**FINAL DRAINAGE REPORT**

**Lot 3A Northcrest Center Filing No 1A  
(My Garage @ Northcrest Center)**

**PCD File #PPR2412**

Kiowa Project No. 23049

Figure 12-21. Embankment protection details and rock sizing chart (adapted from Arapahoe County)

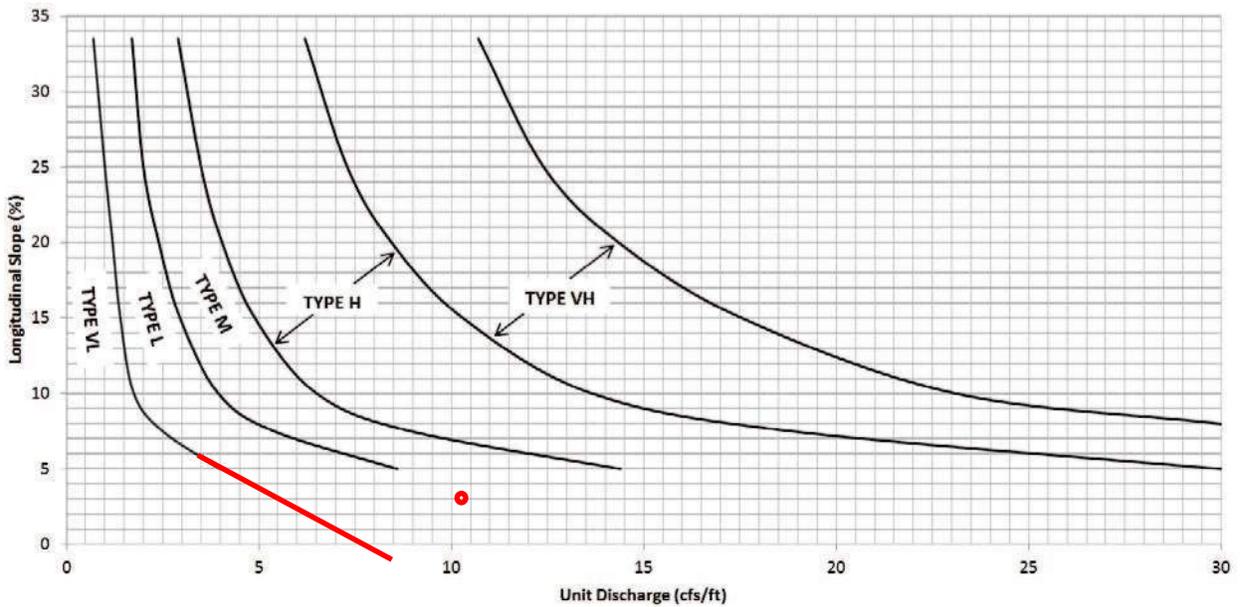
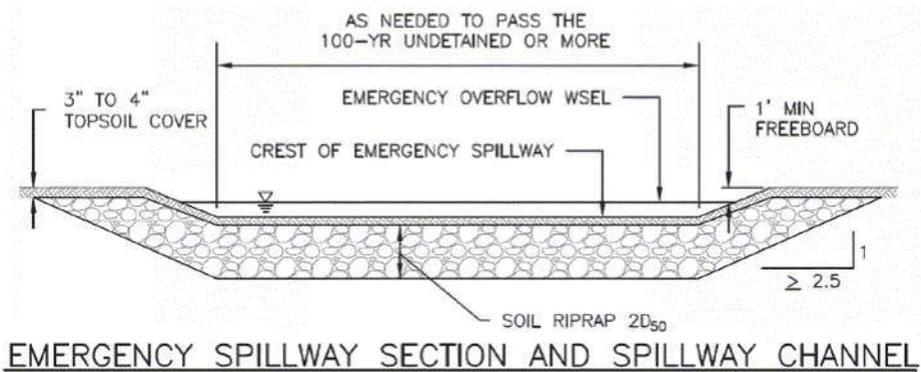
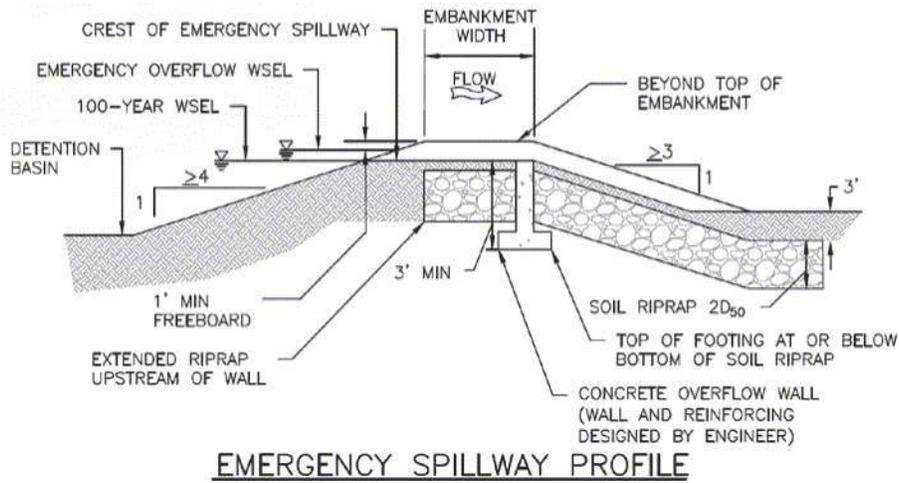
plans show spillway inv at 6512.41. Revise to remove discrepancy.
